Final Debris Removal Activities Summary Report

**Area of Contamination 57, 74, and 50
Former Fort Devens, Massachusetts**

Project Name: Former Fort Devens Army Installation		Report Date:	28 January 2022
Location: Devens, Massachusetts		Reviewer:	Multiple
Document Name: Draft Debris Removal Summary Report			
Prepared By: Seres Arcadis 8(a) JV			
No.	Ref. Page / Para.	COMMENT	RESPONSE
Carol Keating (EPA)			
G1	General	It is unclear, based on the text and figures, what debris was removed. It would be helpful to include a table, similar to Table 1 included in the Final Debris Removal Work Plan (August 2021), that notes if a particular piece of debris was removed, not found, etc.	A table (Table 1) has been added to the report per the comment.
G2	General	Please add figures that show where observed debris was left in place and where, based on the geophysical investigation, suspected metal debris and or other objects may be located. Please also include a table listing such debris, similar to Table 1 included in the Final Debris Removal Work Plan (August 2022).	The figures in Appendix C show the areas where subsurface debris remains. All surface debris that could be removed using manual m

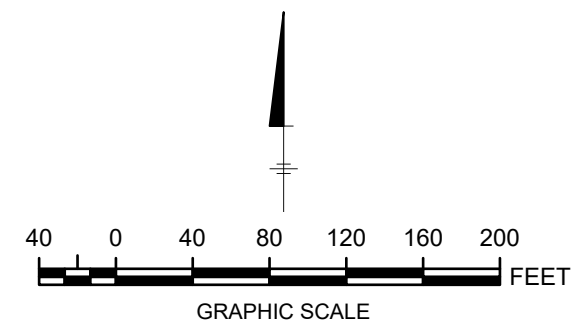
10		Figure 2 – See Page-Specific Comment 1. above.	See response to Comment 1.
11		Figures 2, 3 and 4 – Please expand the “Geophysical Survey Boundaries” on these figures to match those presented in Figure 2 of the Geophysical Survey report (Appendix C).	The figures have been revised.
12		Appendix C, Geophysical Survey, Figure 5 - All graphics are labeled “EM Survey”. Please correct.	The figure has been revised.

4	Appendix A, Photos 1 and 3	Please confirm these AOC 57 locations are shown in Figure 2 or add them to Figure 2 for future reference.	The locations have been added to Figure 2.
